Declaration of 1 August 2013  
by Gordon R. Thompson:

Comments on the US Nuclear Regulatory Commission's  
Draft Consequence Study of a Beyond-Design-Basis  
Earthquake Affecting the Spent Fuel Pool  
for a US Mark I Boiling Water Reactor

**Figure VII-1**  
**One of the Pool Layouts Modeled in NRC's Draft Consequence Study: The OCP2, High-Density, 1x4 Case**

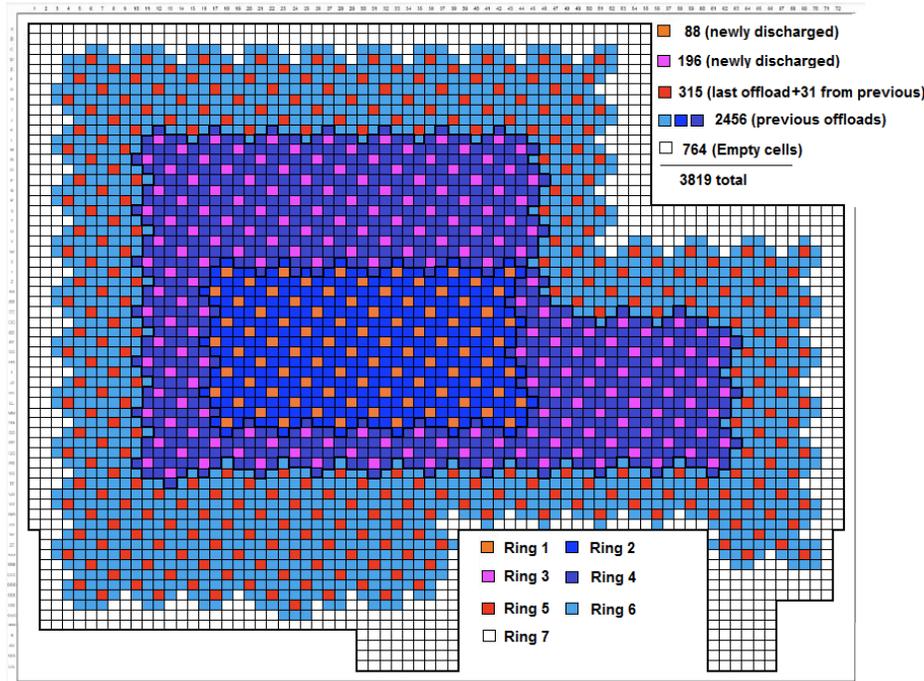
(VI-7) The implications of the presence of residual water for fuel ignition are illustrated by some simple calculations set forth in Section VII, below. These calculations assume a pool loading (see Figure VII-1) and operating cycle phase (OCP4) as used in NRC’s Draft Consequence Study. The contrast with that study is that drainage of water would

(VII-5) In addition to questions about the validity of MELCOR, there are questions about NRC's input assumptions. For example, how closely does the pool layout shown in Figure VII-1 correspond with actual practice in the nuclear industry? In that context, there is a puzzling NRC assumption associated with Figure VII-1. That figure shows a total of 284 newly-discharged fuel assemblies. Of these, 88 assemblies are assumed by NRC to produce decay heat at the rate of 10.9 kW per assembly when aged 20 days,

while the remaining 196 assemblies produce 6.6 kW per assembly at the same age.<sup>47</sup> If this is typical practice, then licensees are forgoing substantial available burnup of the majority of their fuel assemblies, with a resulting economic penalty.<sup>48</sup> As a related matter, Figure VII-1 shows a rather elaborate layout of fuel, whose achievement would involve substantial shuffling of assemblies. NRC says that this layout is comparatively favorable in terms of the risk of a pool fire. Yet, licensees are allowed a period of time, during and perhaps after a refueling outage, to perform the shuffling needed to achieve a favorable layout. The length of that period of time is a secret because, NRC says, this information could be useful to an adversary.<sup>49</sup> Thus, is it appropriate to assume, as a MELCOR input, that a comparatively favorable layout has been achieved before water is lost?

**Figure VII-2**  
**Findings from NRC's Draft Consequence Study: Water Level and Ring 1 Cladding Temperature for Unmitigated High-Density Moderate Leak (OCP4)**

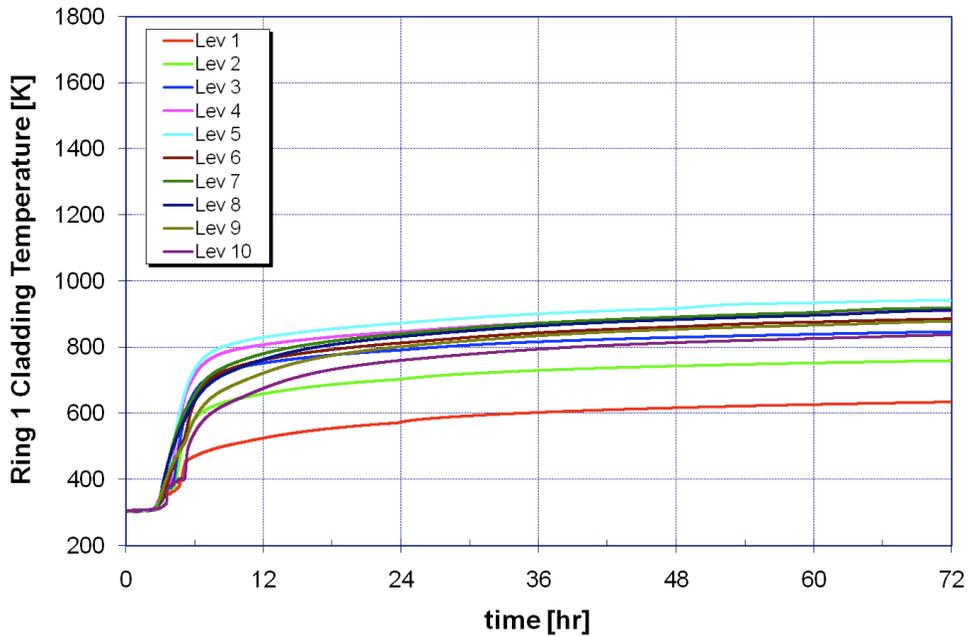
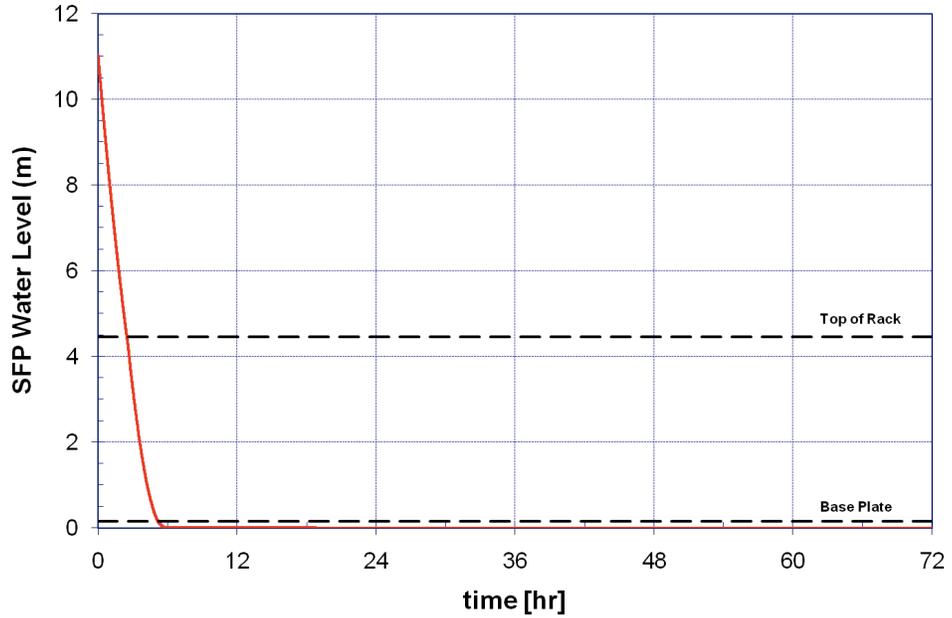
(VI-11) These illustrative calculations show that a pool fire could occur if water loss occurred during a particular operating cycle phase – OCP4. NRC’s Draft Consequence Study finds (see Figures VII-2 and VII-3) that a pool fire would not occur in OCP4 with the same pool loading. That finding reflects NRC’s decision to focus its analysis exclusively on water-loss scenarios involving total drainage of water from a pool. By adopting that focus, NRC has ignored a substantial part of the pool-fire risk.

(VII-10) Now, consider MELCOR outputs for NRC's examination of a moderate-leakage case in OCP4, as shown in Figure VII-2. During the evolution of this case, there would be a period of time when the upper portion of the fuel is exposed and residual water is present. That period would extend from about  $t = 3$  hours to about  $t = 6$  hours. During that 3-hour period, at the "Lev 5" elevation of the fuel, cladding temperature would rise from about 300 K to about 700 K. Thus, the average rate of temperature rise would be about 130 K per hour. This finding indicates that the exposed portion of the fuel at the Lev 5 elevation would be in an approximately adiabatic situation, at least for temperatures up to 700 K.

**Figure VII-3**  
**Findings from NRC's Draft Consequence Study: Water Level and Ring 1 Cladding Temperature for Unmitigated High-Density Small Leak (OCP4)**

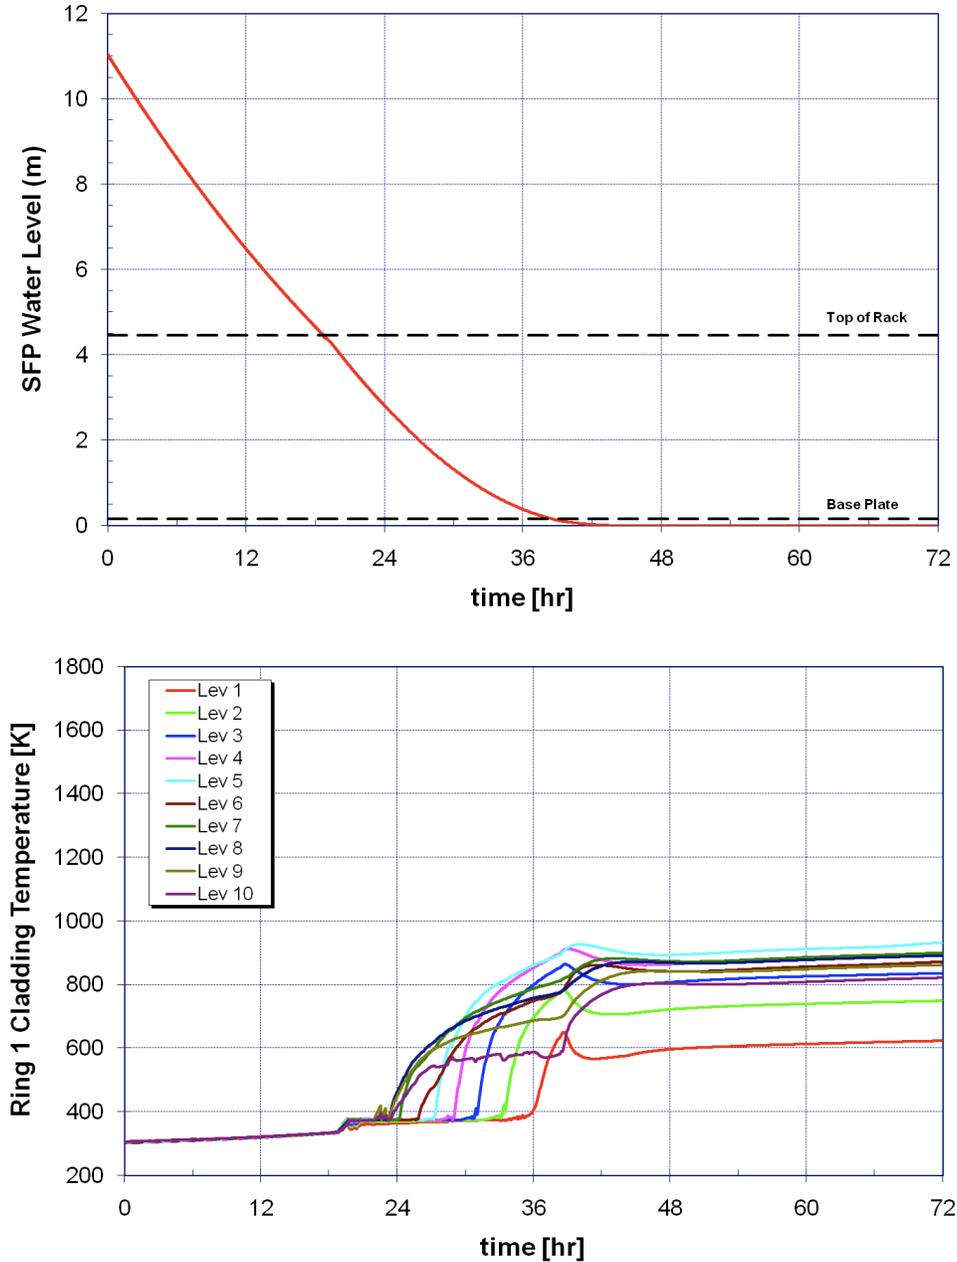
(VII-11) Now, apply the same process, as in the preceding paragraph, to NRC's examination of a small-leakage case as shown in Figure VII-3. In that case, the period of time when fuel at the Lev 5 elevation is exposed and residual water is present would extend from about  $t = 28$  hours to about  $t = 40$  hours. During that 12-hour period, the temperature of fuel cladding at the Lev 5 elevation would rise from about 350 K to about 900 K. Thus, the average rate of temperature rise would be about 46 K per hour.
